## SERVICE INFORMATION NO. SI36-064

EASA Airworthiness Directive  
No: 2011-0082

<b>Type Approval Holder's Name:</b>		<b>Type/Model designation(s):</b>
BRP-Powertrain GmbH & Co. KG		Rotax 914 F series engines
TCDS Number:	EASA.E.122	
Foreign AD:	Not applicable	
Supersedure :	None	
<b>ATA 73</b>	<b>Engine Fuel &amp; Control – Fuel Pressure Regulator – Identification / Replacement</b>	
Manufacturer(s):	BRP-Powertrain GmbH & Co. KG, BRP-Rotax GmbH & Co. KG; Bombardier-Rotax GmbH & Co. KG; Bombardier-Rotax GmbH	
Applicability:	<p>Rotax 914 F2, 914 F3 and 914 F4 engines, all serial numbers.</p> <p>These engines are known to be installed on, but not limited to, the following types of aeroplanes (mostly powered sailplanes): <b>Aeromot</b> AMT-300 Turbo Super Ximango, <b>Aircraft Philipp</b> (formerly Alpha-Werke; Nitsche) AVO 68 series Samburo, <b>Diamond</b> (formerly HOAC) HK 36 series Super Dimona, <b>Scheibe</b> SF 25C and <b>Stemme</b> S10-VT.</p> <p><b>Note:</b> The installation of these engines was either done by the respective <b>aeroplane manufacturer</b> or through modification of the aeroplane by Supplemental Type Certificate.</p>

**SERVICE BULLETIN**  
**REPLACEMENT OF**

BILD 1

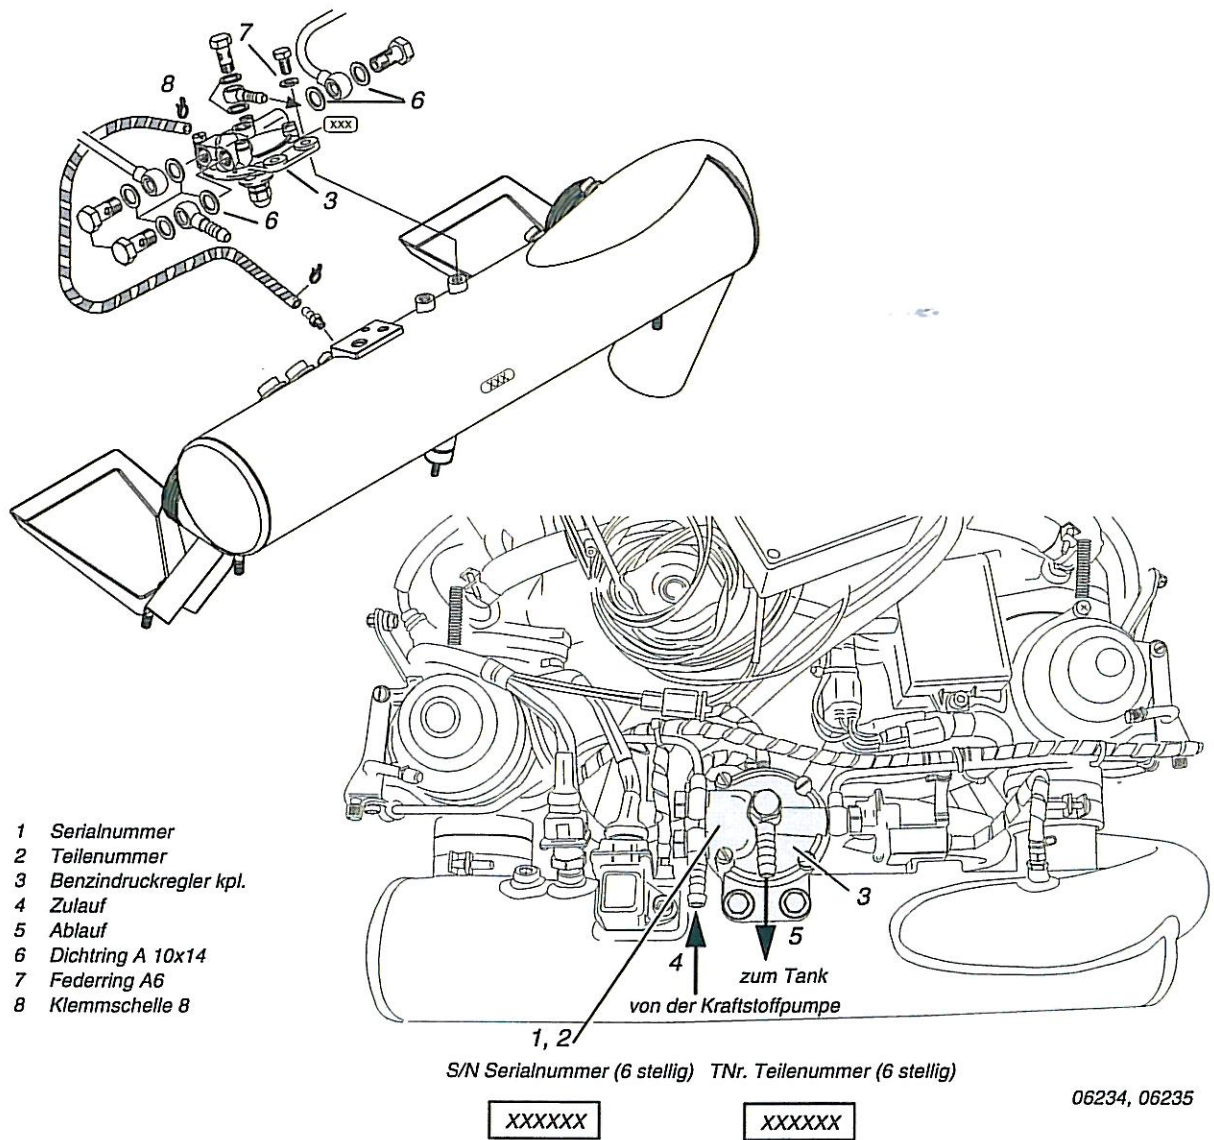
- ◆ **HINWEIS:** Die jeweilige Seriennummer (1) und die Teilenummer (2) des Benzindruckreglers (3) ist auf dem Benzindruckreglerflansch ersichtlich (siehe Bild 1).

Vereinzelte Fertigungsabweichungen am Gewinde des Benzindruckreglers könnten in späterer Folge zu leichten Undichtheiten im Bereich der Hohlschraube für die Retourleitung zum Tank führen.

Austausch des Benzindruckreglers kpl. TNR. 887130 für ROTAX® Motortype 914 (Serie).

1. Sichtkontrolle des Benzindruckreglers kpl. (1).
2. Demontage des alten Benzindruckreglers kpl. gemäß entsprechendem Wartungshandbuch.
3. Montage des neuen Benzindruckreglers kpl. gemäß entsprechendem Wartungshandbuch.

1. Kontrolle des Kraftstoffdruckes (ca. 250 hPa über dem Airboxdruck). Gegebenenfalls Einstellen des Kraftstoffdruckes gemäß entsprechendem Wartungshandbuch.

Fig. 1

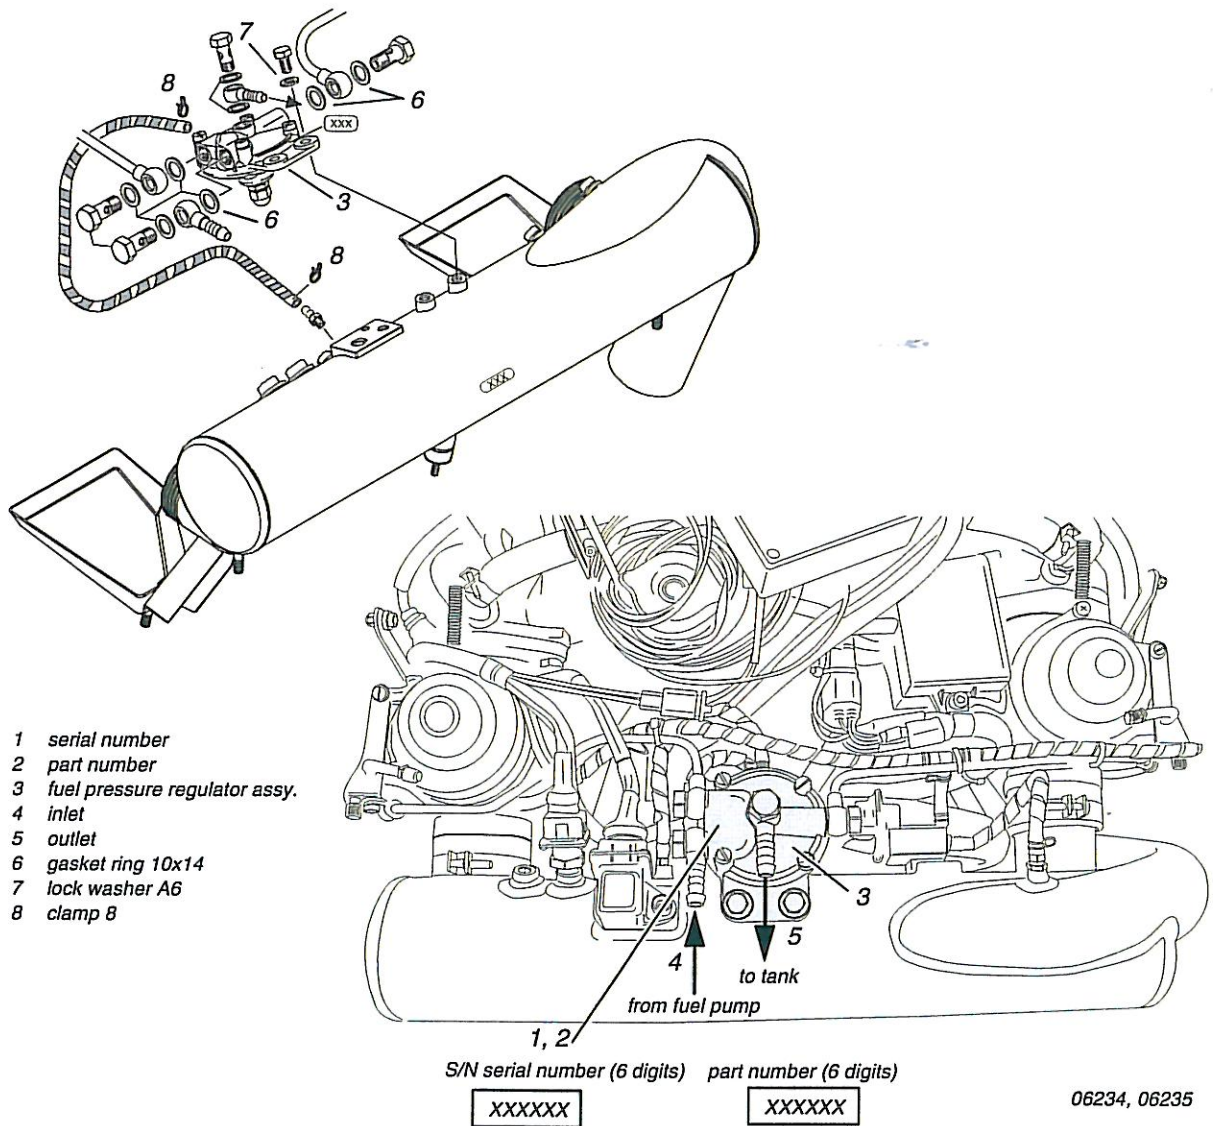
- ◆ **NOTE:** The corresponding serial number (1) and part number (2) is visible on the flange of the fuel pressure regulator assy. (3) (see fig. 1).

Isolated manufacturing deviations at the threads of the fuel pressure regulator could result in slightly leaks in the area of the banjo bolt for the fuel return to tank.

Replacement of fuel pressure regulator assy. part no. 887130 for ROTAX® engine type 914 (Series).

1. Visual check of the pressure regulator assy. (3).
2. Fuel pressure regulator assy. disassembly in accordance with the relevant Maintenance Manual.
3. Fuel pressure regulator assy. assembly in accordance with the relevant Maintenance Manual.

1. Check the correct fuel pressure (approx. 250 hPa above the airbox pressure). If necessary, adjust the fuel pressure in accordance with the relevant Maintenance Manual.
